MILITARY SPECIFICATION

Module, Plug-In, Automatic Lead Selector,
In-Circuit Checker for Test Set, Transistor:
AN/USM 136

This amendment forms a part of Military Specification MIL-T-55204(MU), 2 November 1962.

FIGURE 1. AUTOMATIC LEAD SELECTOR IN-CIRCUIT CHECKER TEST CIRCUIT

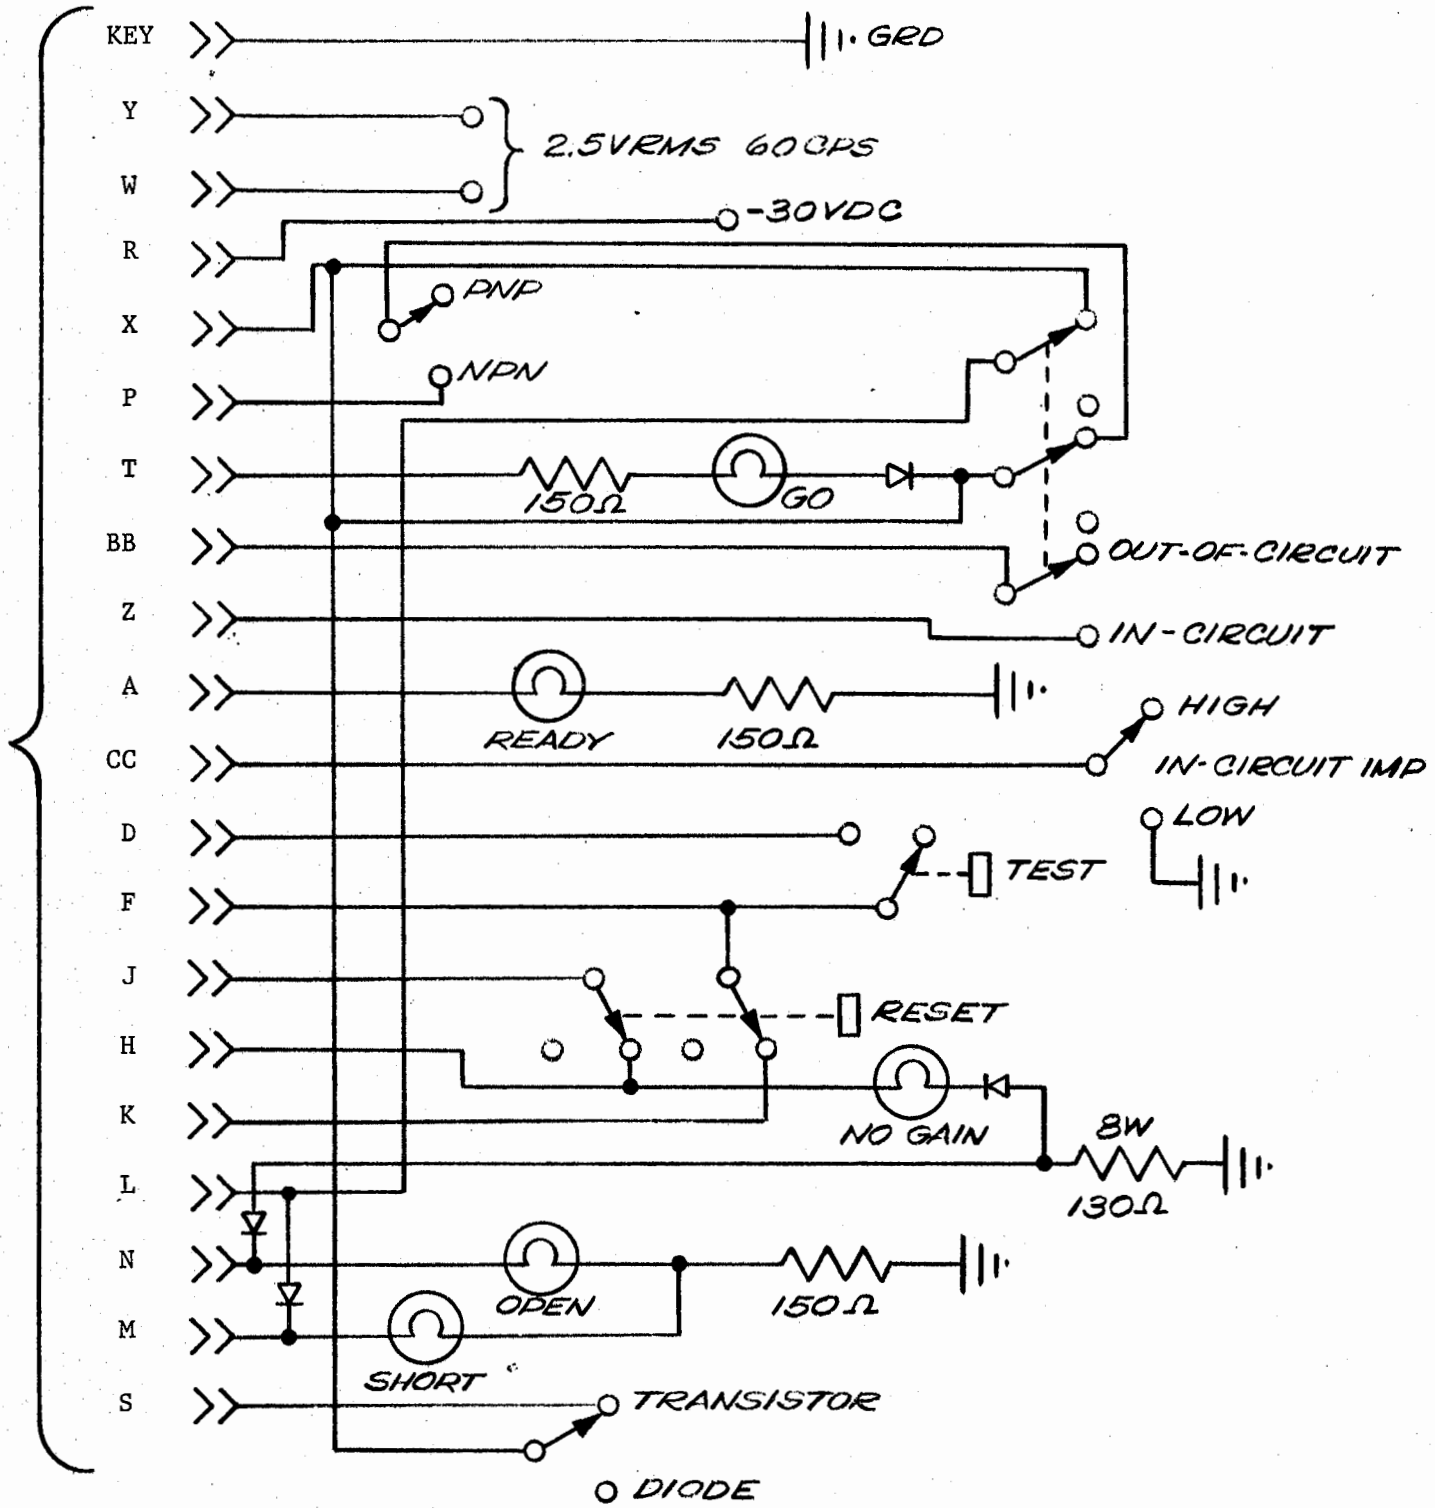
"The ALS projection readout noted as part of Figure 1 must be used to determine lead, polarity and material finding action."

Figure 1: Delete and substitute revised Figure 1.
